Re: Children's Promise Centers LLC 401 Alvarado Dr. SE Traffic Circulation Layout Architect's Stamp 08-04-22 (K18-D022)

Based upon the information provided in your submittal received 10-13-22, the above referenced plan cannot be approved for Building Permit until the following comments are addressed:

Architectural Site Plan Traffic Circulation Layout

AS101

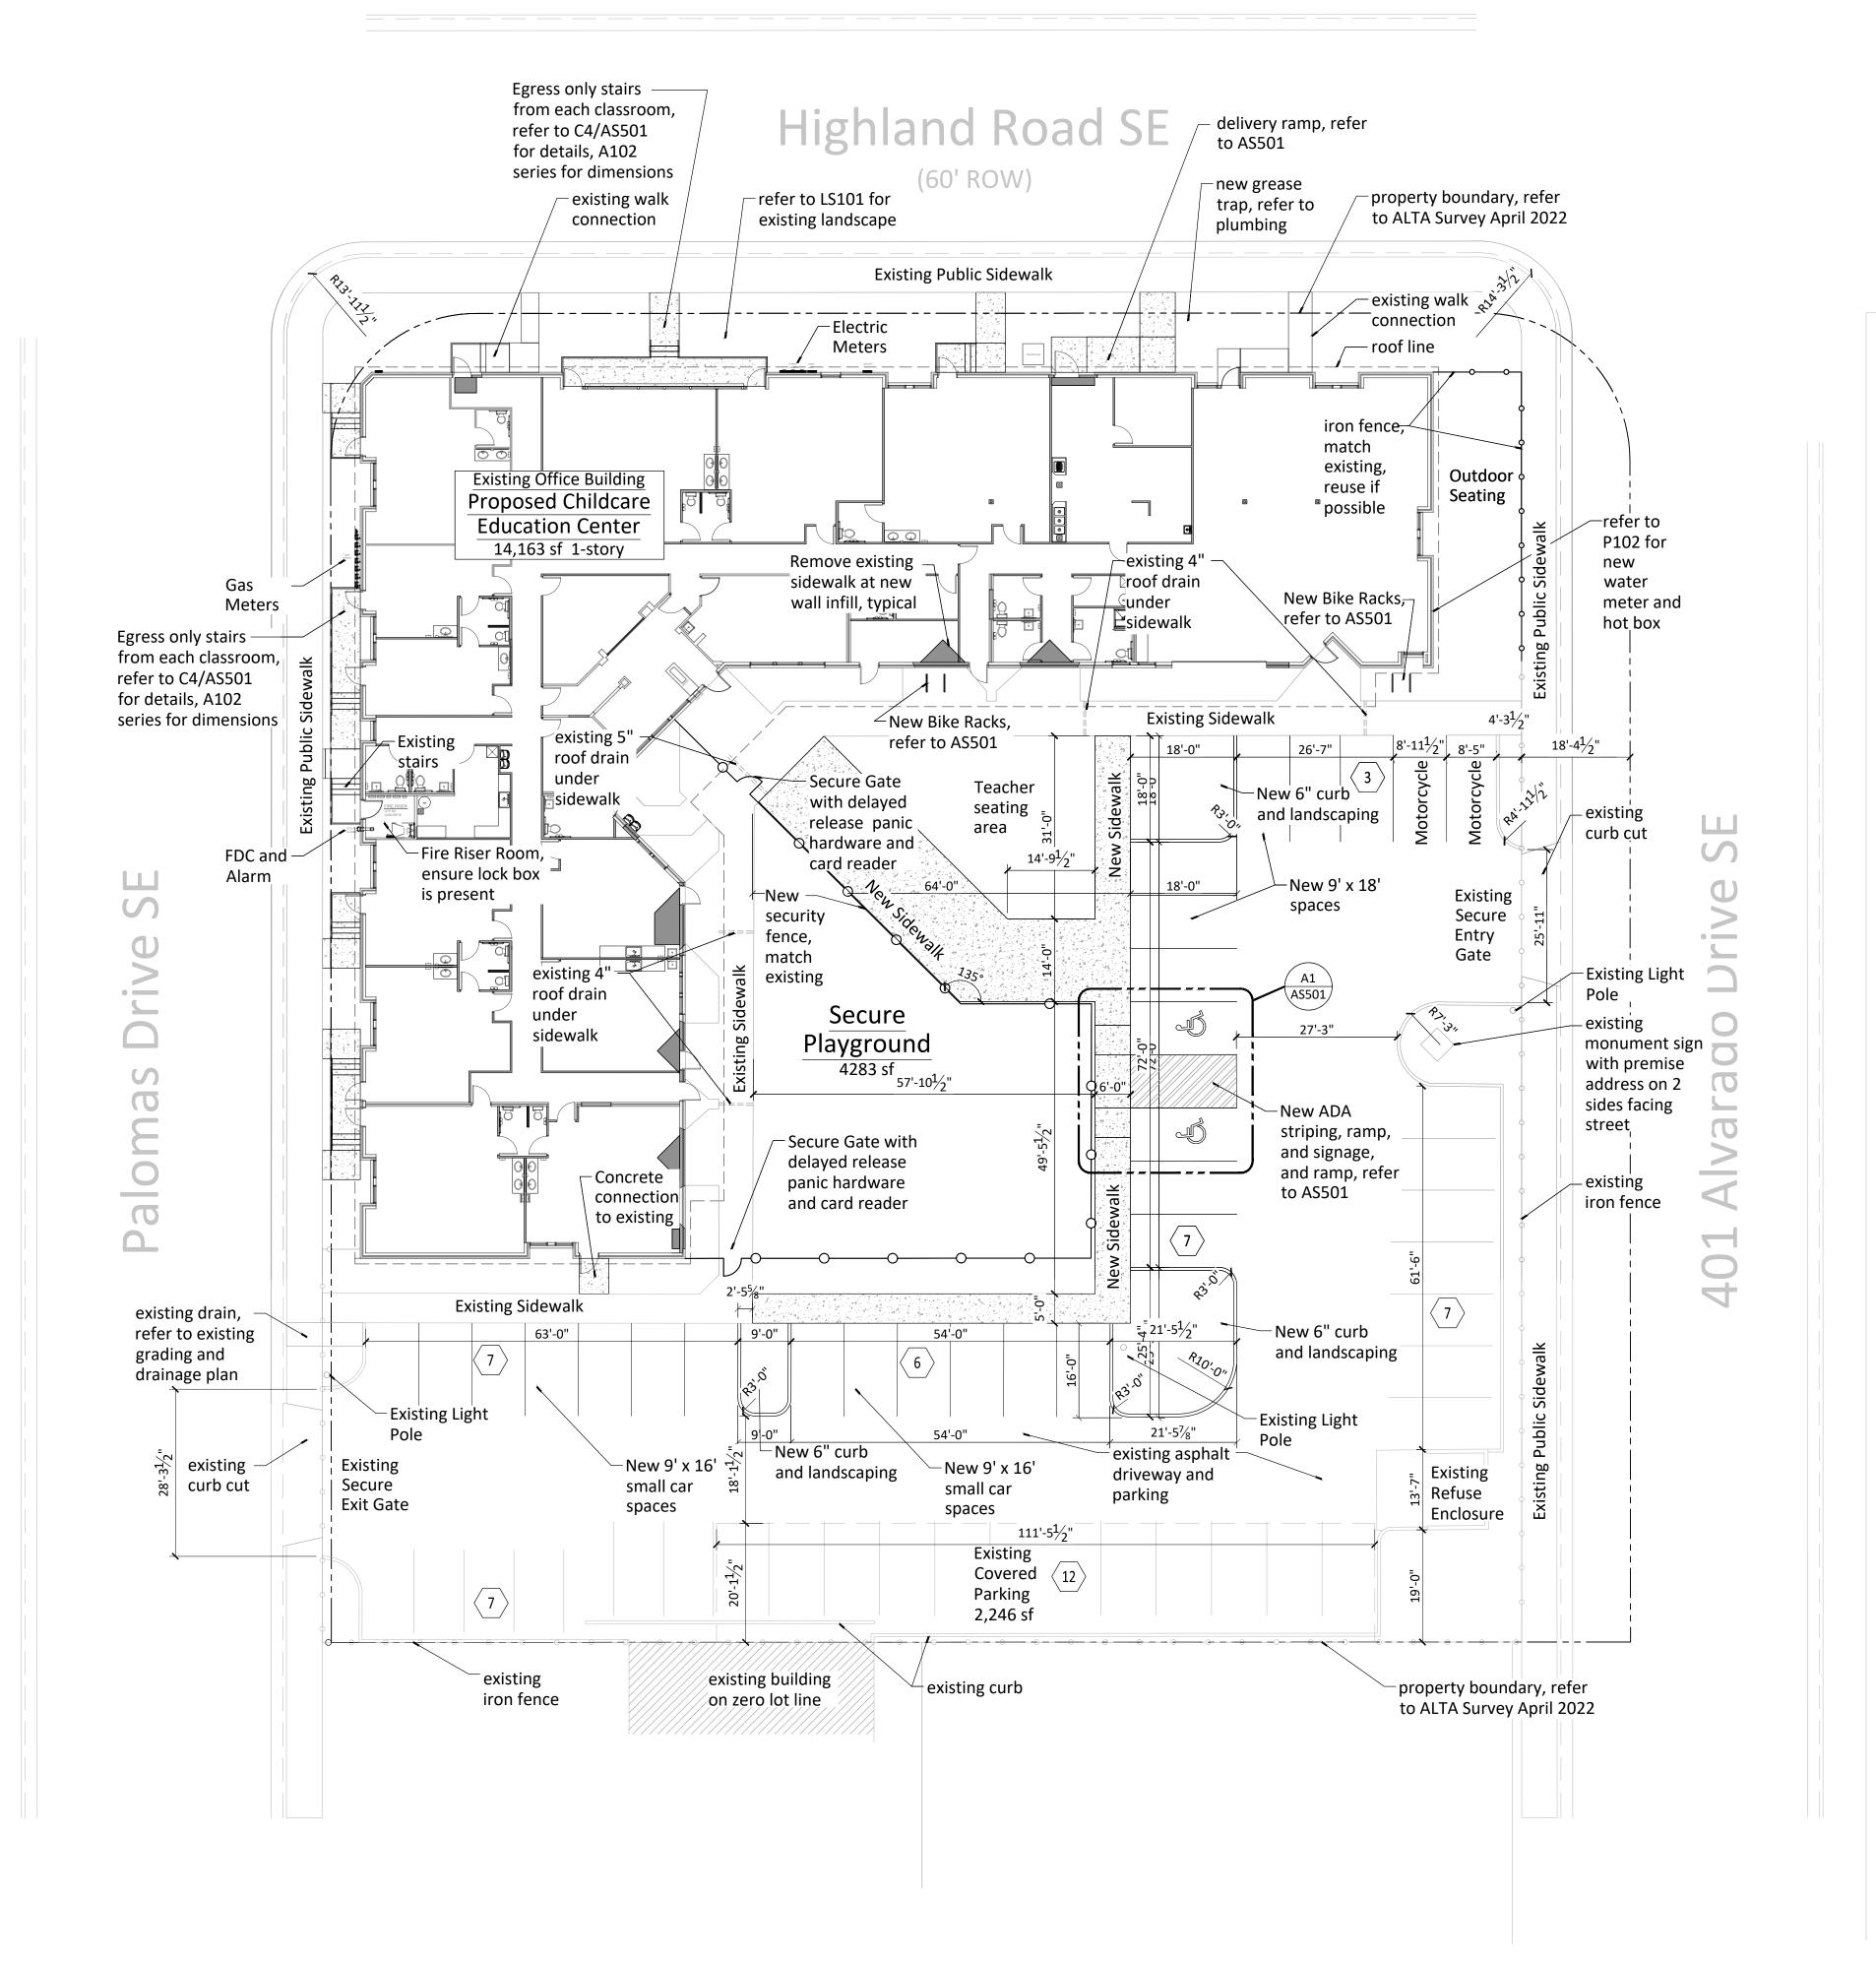
1. Identify the right of way width, medians, curb cuts, and street widths on Alvarado Dr., Highland Rd., and Palomas Dr. SE.

- 2. Clarify existing property lines and proposed property lines.
- 3. Site accesses: Driveway accesses off Alvarado Dr., and Palomas Dr. should Curb Return Design with minimum 20 ft. radii.

- 4. Due to proposing gates, please provide Vehicle Turning Template.
- 5. Label the compact parking spaces by placing the words "COMPACT" on the pavement of each space.

6. ADA curb ramp at the corner of Alvarado dr. and Highland rd. must be updated to current standards and have truncated domes installed.

- 7. ADA curb ramp at the corner of Highland rd. and Palomas dr. must be updated to current standards and have truncated domes installed.
 - 8. The pavement marking "MC" should be shown in the opposite direction for motorcycles entering the parking space.
- 9. Per the IDO, a 6 ft. wide ADA accessible pedestrian pathway is required from the public sidewalk to the building entrances. Please clearly show this pathway and provide details.
- 10. All sidewalks along streets should be placed at the property line.
- 11. Curbing should be installed to delineate landscape, parking, and pedestrian ways and identify points of access. Please call out detail and location of barrier curb.
- 12. Refuse vehicle maneuvering shall be contained on-site. The refuse vehicle shall not back into the public right of way.; provide a copy of refuse approval.
- 13. Provide a copy of Fire Marshal approval.

- 14. It is not apparent what type of pavement surface is being proposed. A hard driving surface will be required as part of this proposed project for parking area and drive aisles.

- 15. Show the clear sight triangle and add the following note to the plan: "Landscaping and signage will not interfere with clear sight requirements. Therefore, signs, walls, trees, and shrubbery between 3 and 8 feet tall (as measured from the gutter pan) will not be acceptable in the clear sight triangle.

- 16. Please specify the City Standard Drawing Number when applicable.
- 17. Add a note stating "All broken or cracked sidewalk must be replaced with sidewalk and curb & gutter." A build note must be provided referring to the appropriate City Standard drawing.
